50-286

APPENDIX
TO
COMMENTS OF CON EDISON
ON
DRAFT ENVIRONMENTAL STATEMENT
RELATED TO THE OPERATION OF
INDIAN POINT NUCLEAR GENERATING PLANT
UNIT NO. 3

Densities for Striped-Bass Post Yolk-Sac Larvae (No./1000 M³) Collected by Tucker Trawl in 10-Mi Intervals; Hudson River Estuary, RM 11-140, May-July 1973

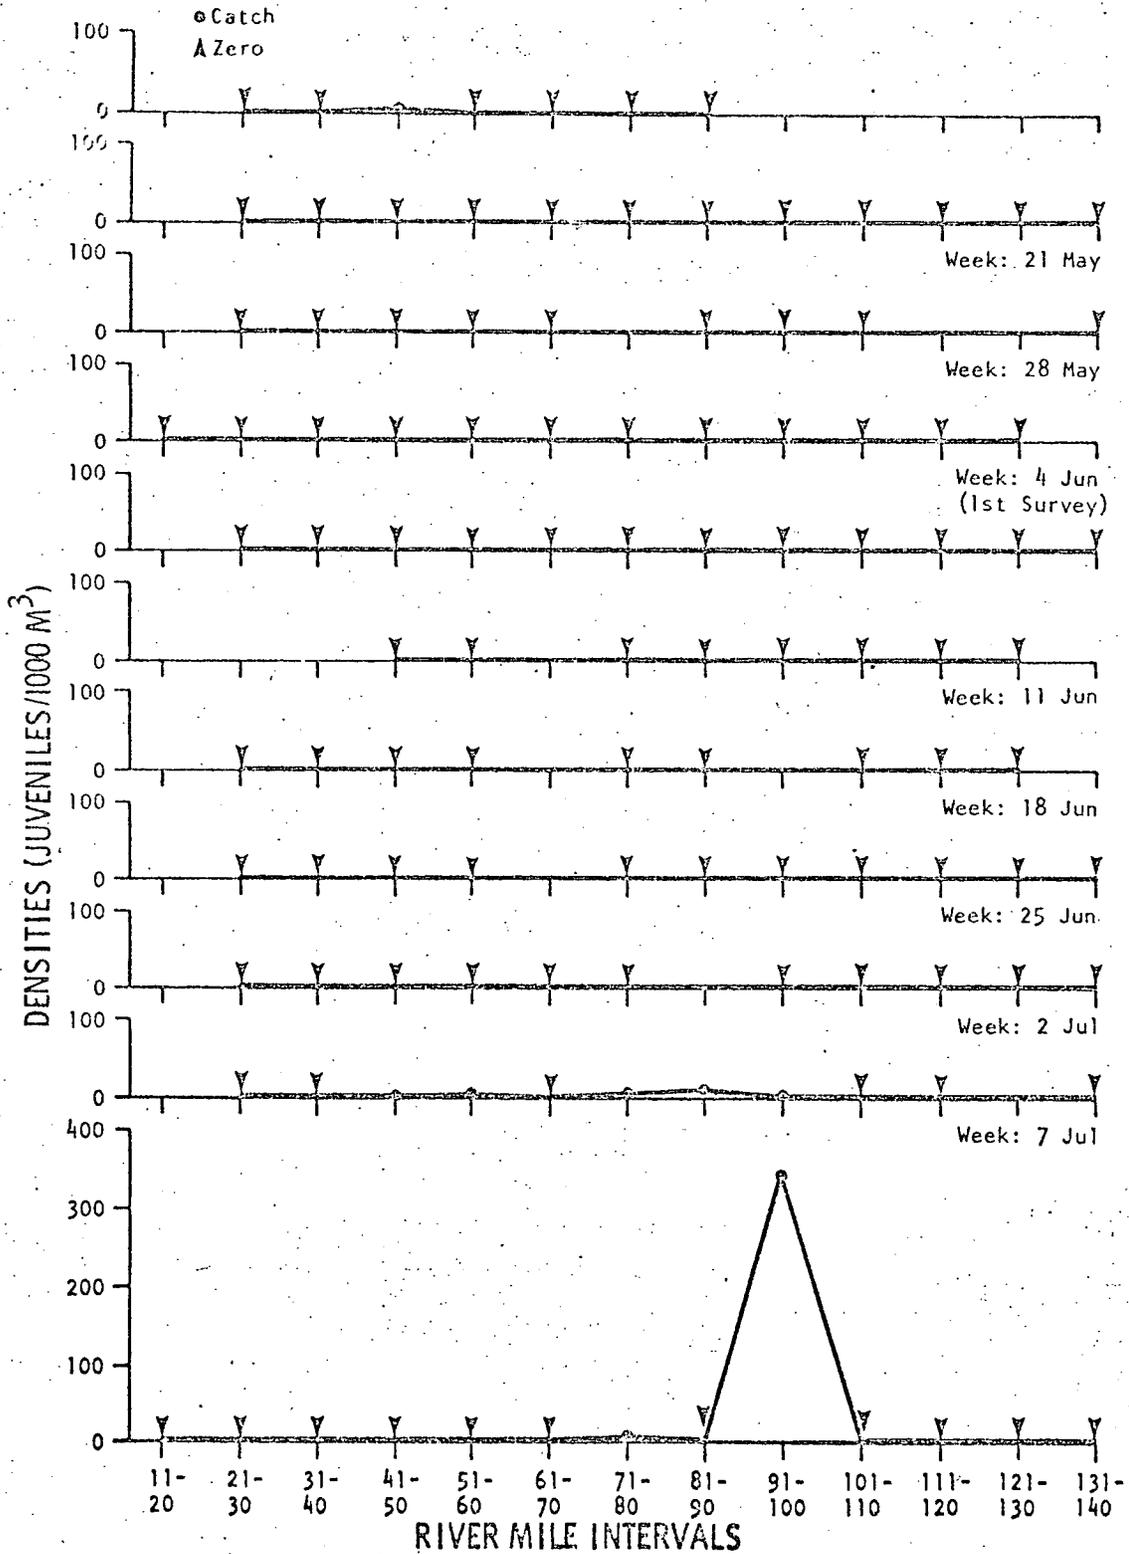
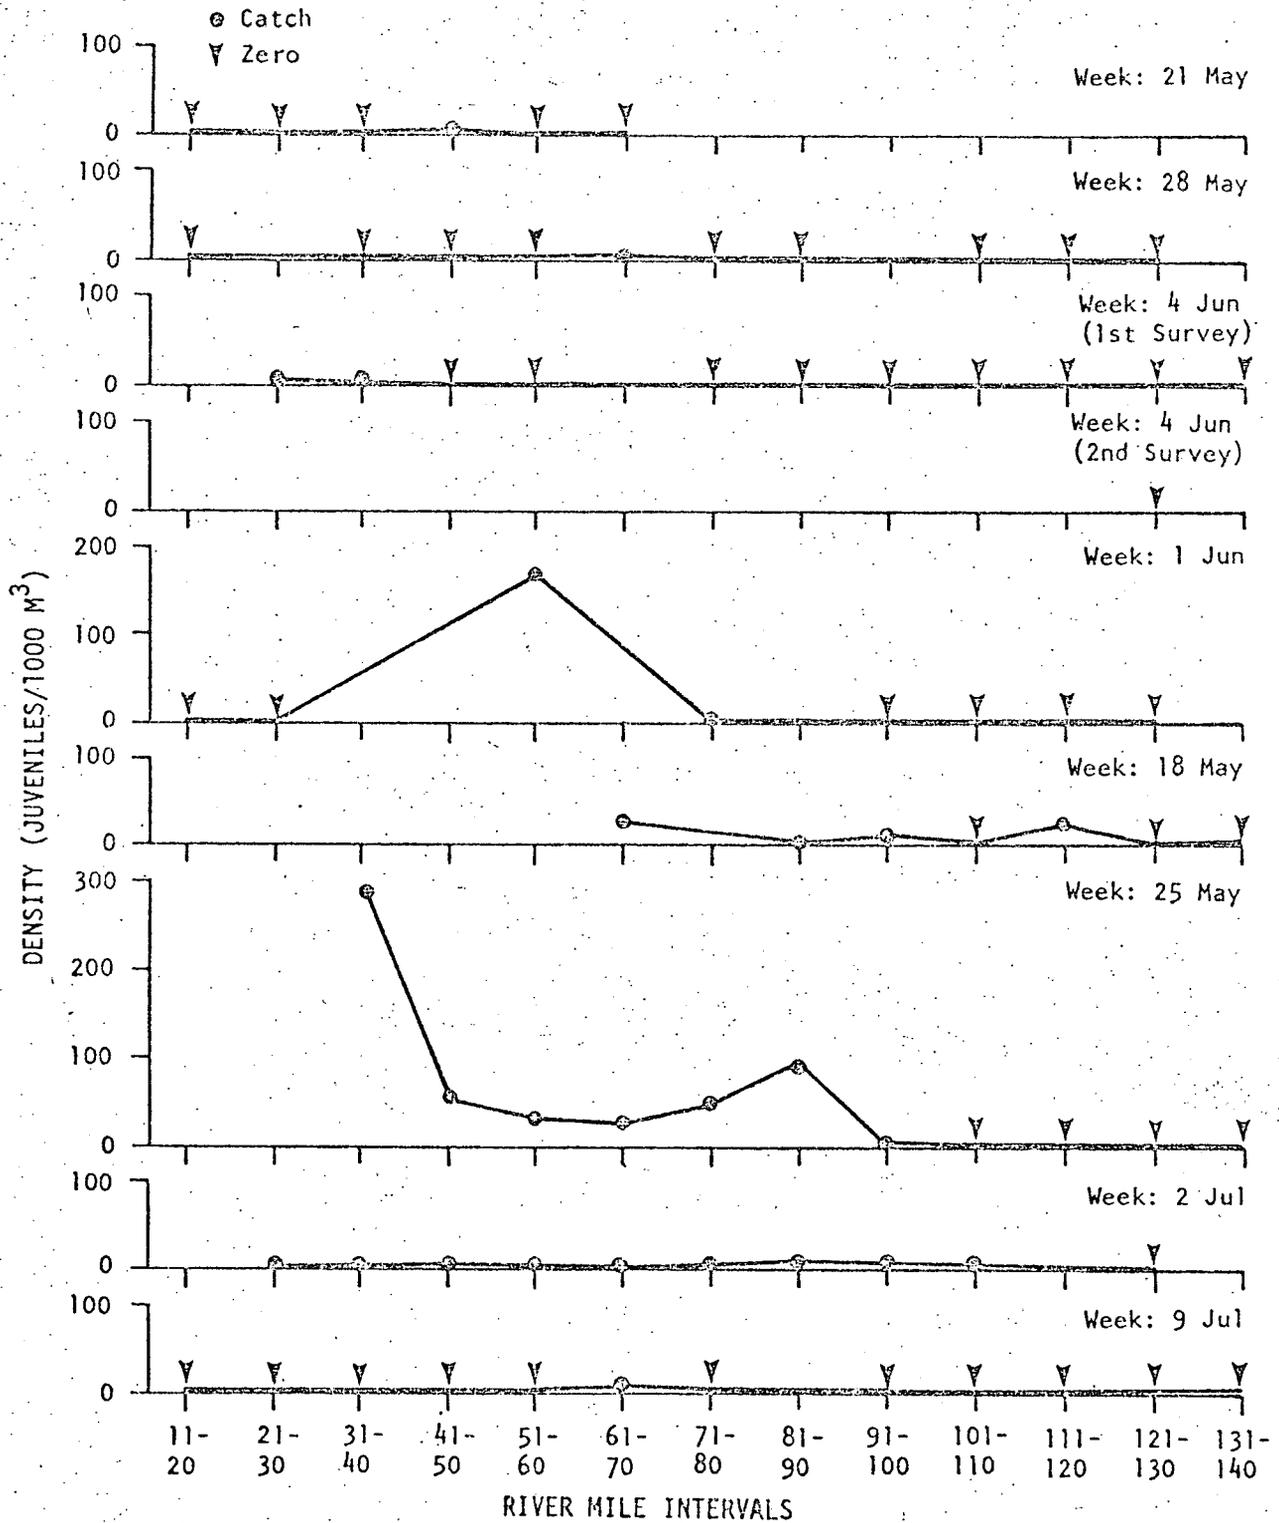
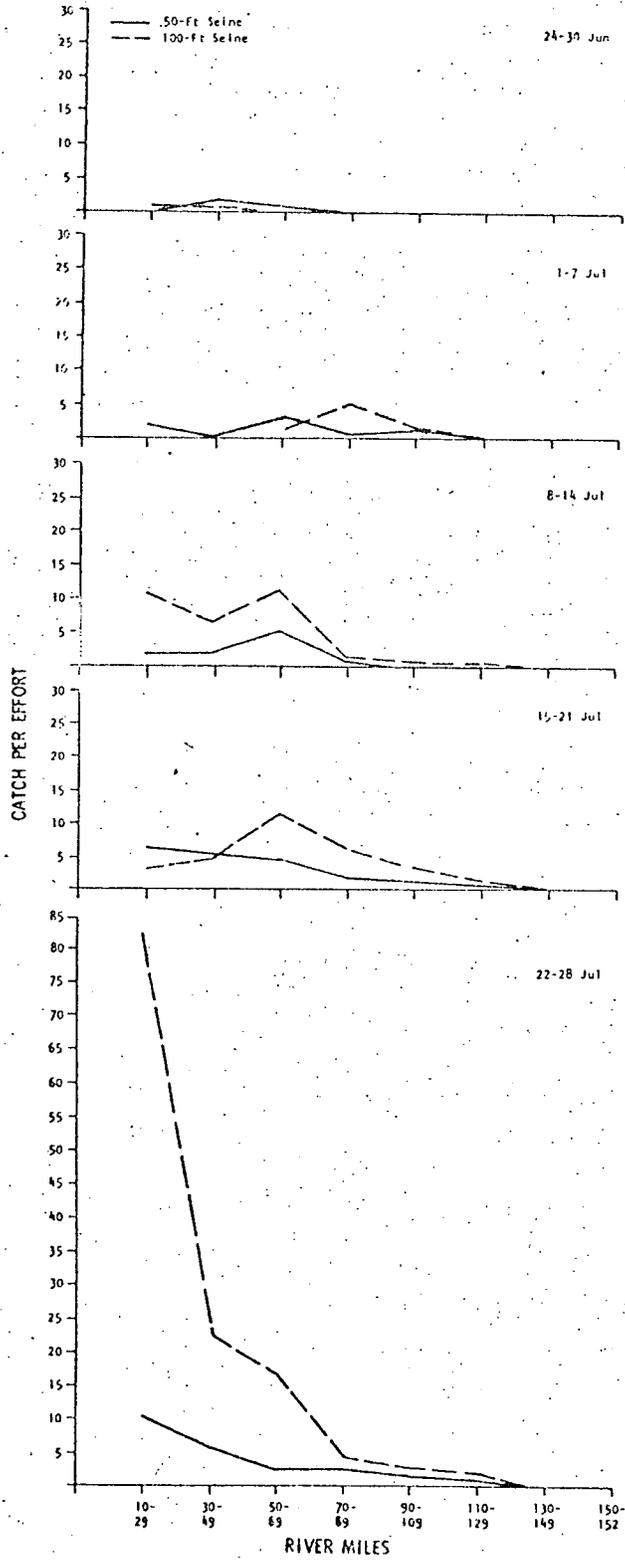
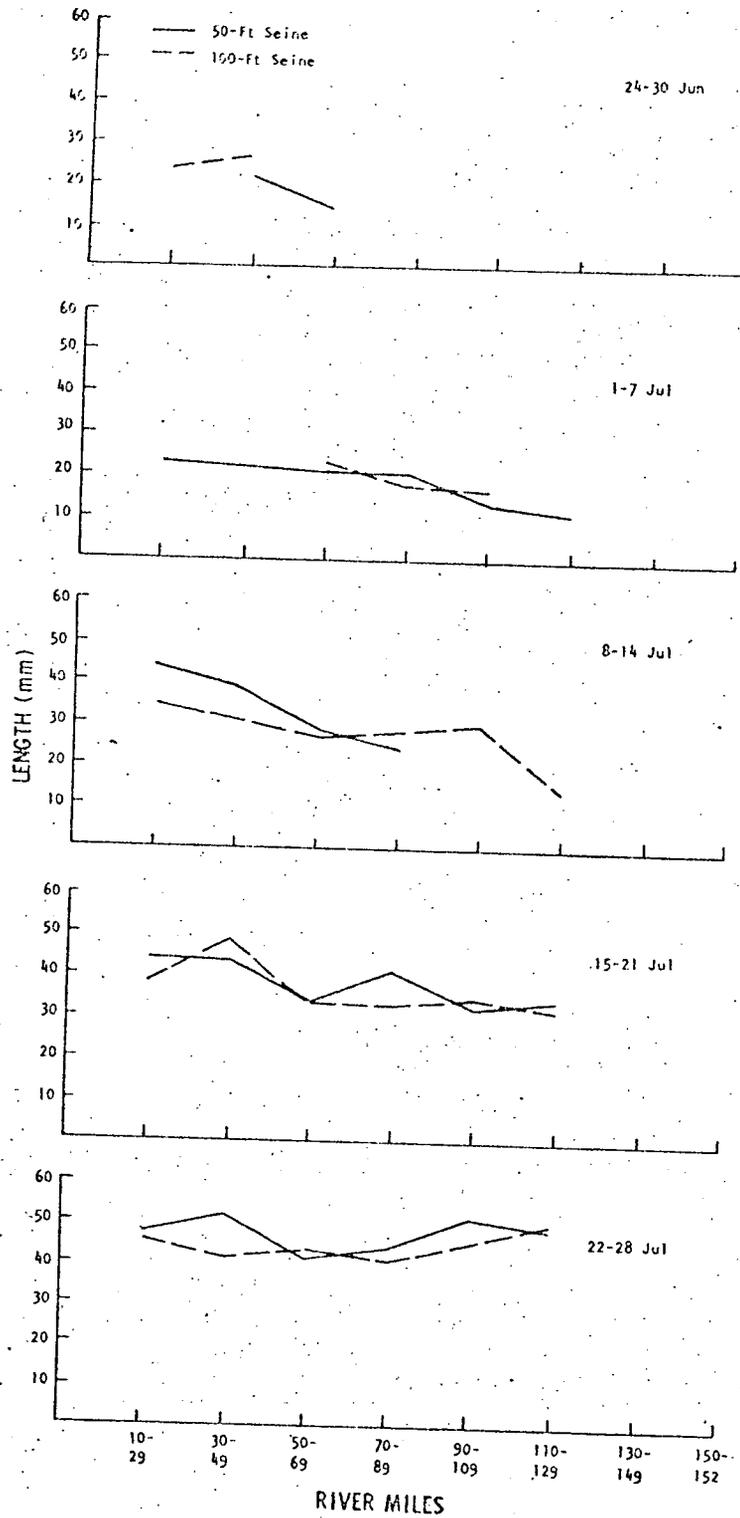
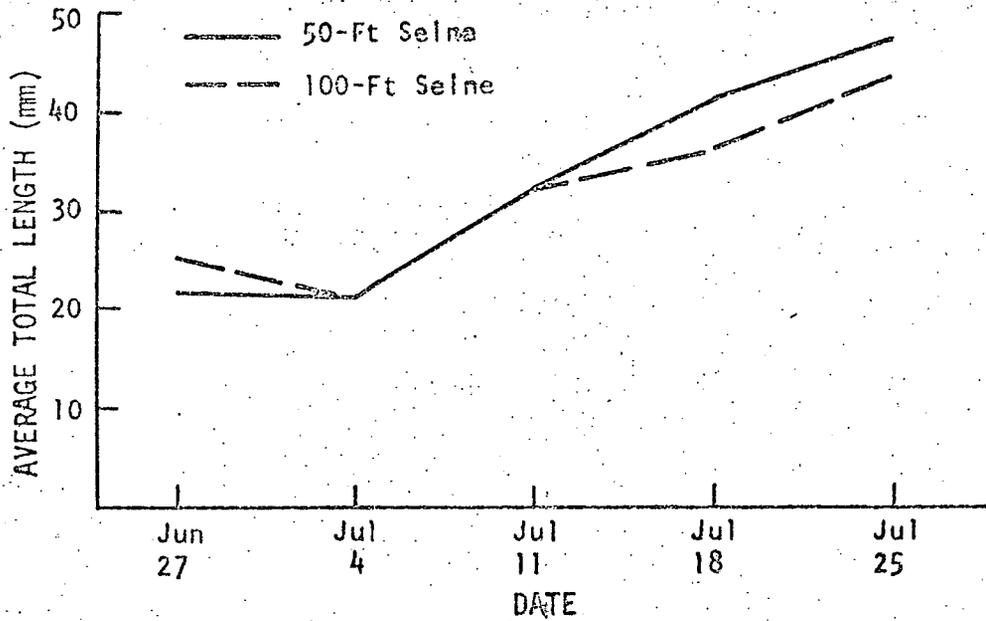
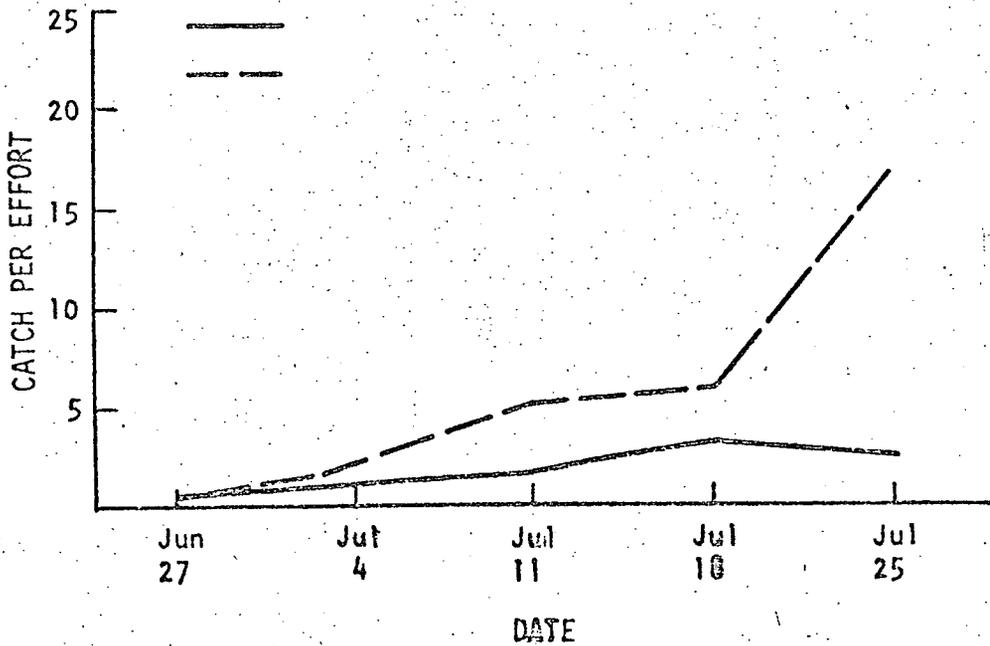
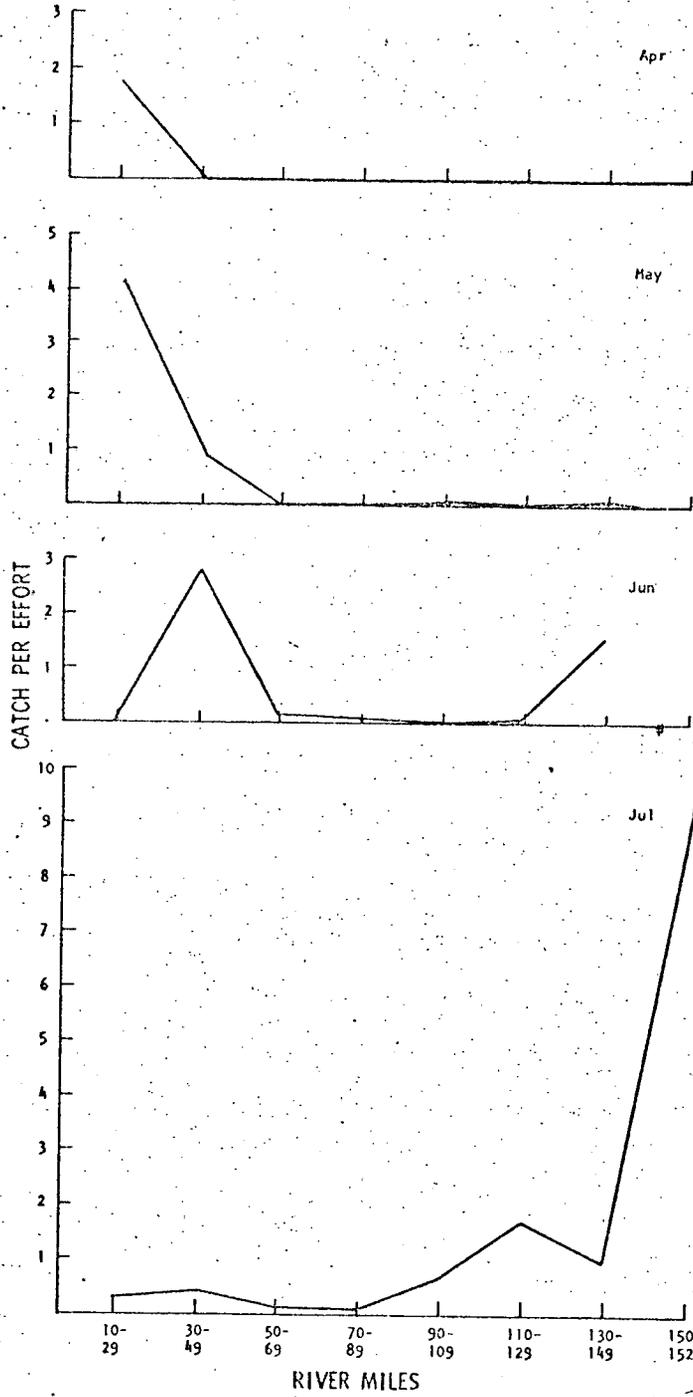
Attached are updated charts showing spatial and temporal distribution of striped bass eggs and larvae in 1973. These should be substituted for the charts on page V-80.

Fig. V-17 Liquid radioactive waste treatment systems for Indian Point Unit No. 3.

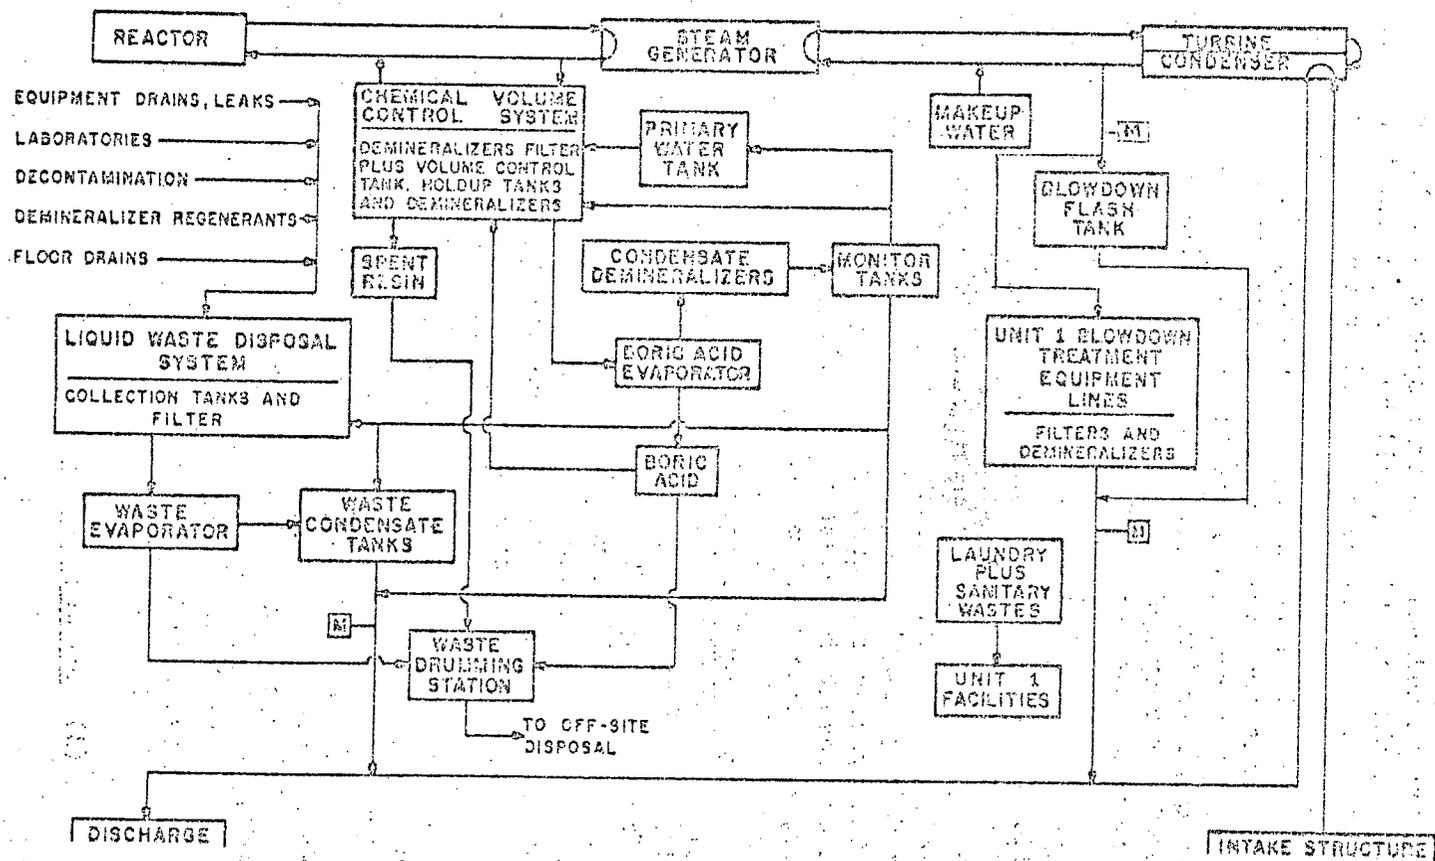
The figure is not totally correct. The corrected version is attached as Exhibit B.
